FAÇADE REVIEW

Re: **FACADE ORDINANCE - Facade Review – FPreliminary S.P.**
Twelve Mile Crossing at Fountain Walk New Retail, SP12-25, & ZCM12-13
 Façade Region: 1, Zoning District: RC, Building Size: 58,500 S.F.

RE: Twelve Mile Crossing at Fountain Walk – New Retail

Re: Preliminary Site Plan Approval
Review Response – Twelve Mile Crossing
At Fountain Walk New Retail

DRAWING TITLE •
PROPOSED EXTERIOR ELEVATIONS

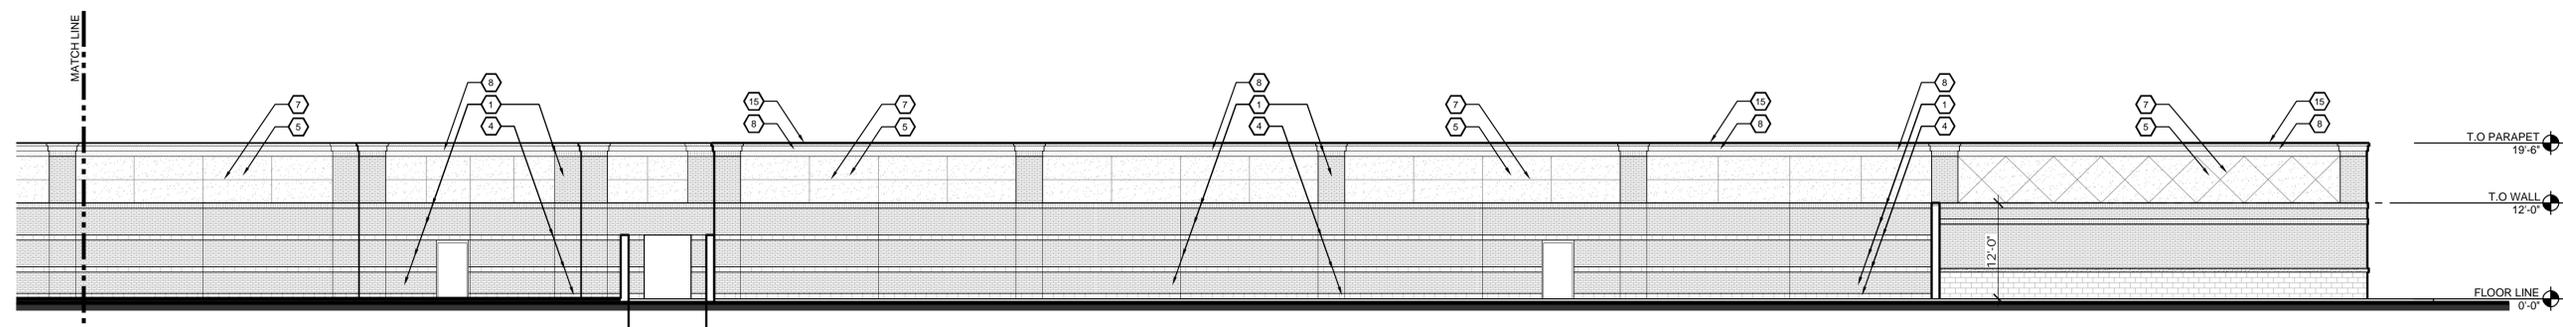
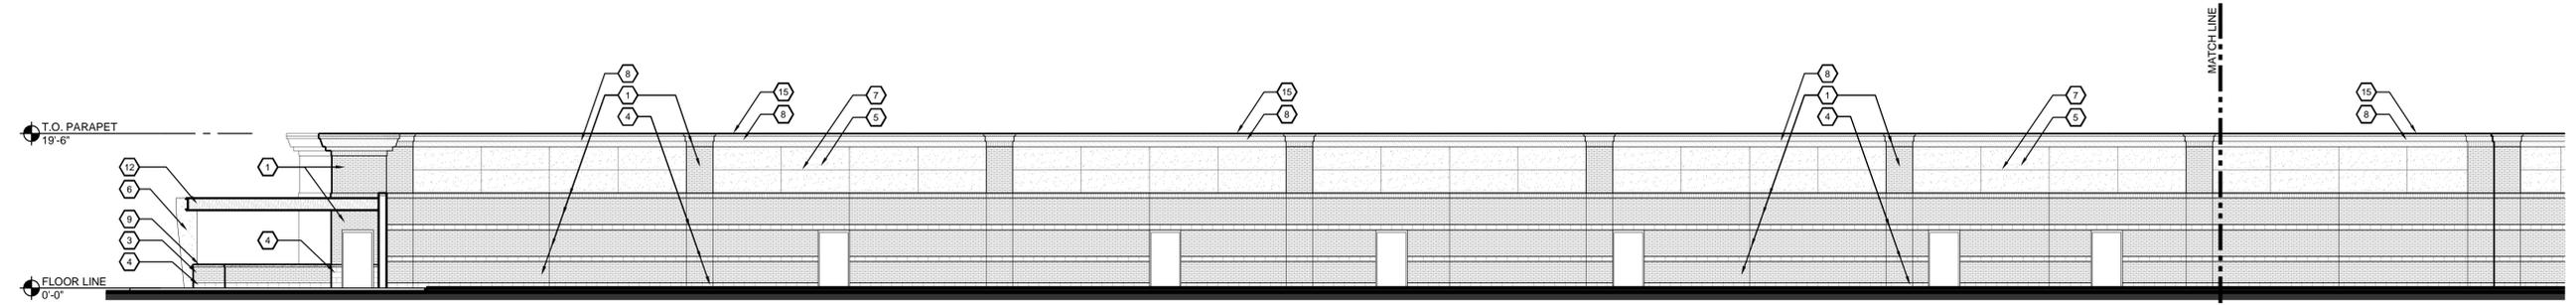
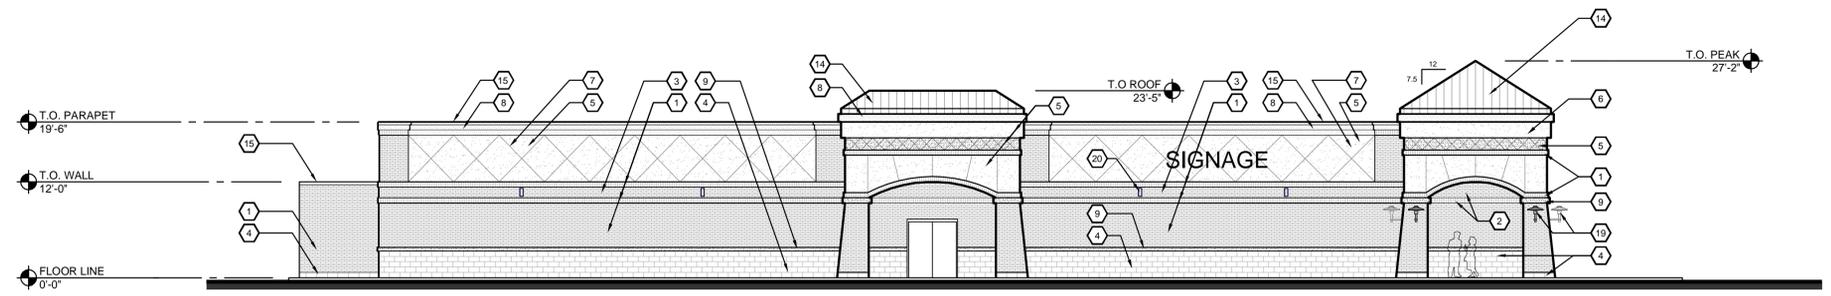
As shown above the percentage of EIFS exceeds the maximum amount allowed by the Façade Chart on all facades.

The areas of EIFS are delineated using interesting joint patterns and are nicely integrated into the overall design of the building. A significant percentage of the EIFS is used to form ornamental cornices, arches and other features that enhance the building's design. It should be noted that a sample board as required by Section 2520.4.d of the Façade Ordinance was not provided at the time of this review. The drawing notation that colors are intended to match existing materials used within the development does not meet the intent of the sample board requirement.

Recommendation - It is our recommendation that a Section 9 Waiver be granted for the overage of EIFS on all facades. This recommendation is contingent upon the applicant providing a sample board illustration colors that are consistent with Section 2520.2 of the Façade ordinance.

1. A materials sample board shall be provided.
2. Roof Appurtenances: The design intent is that the rooftop equipment shall be screened from view.
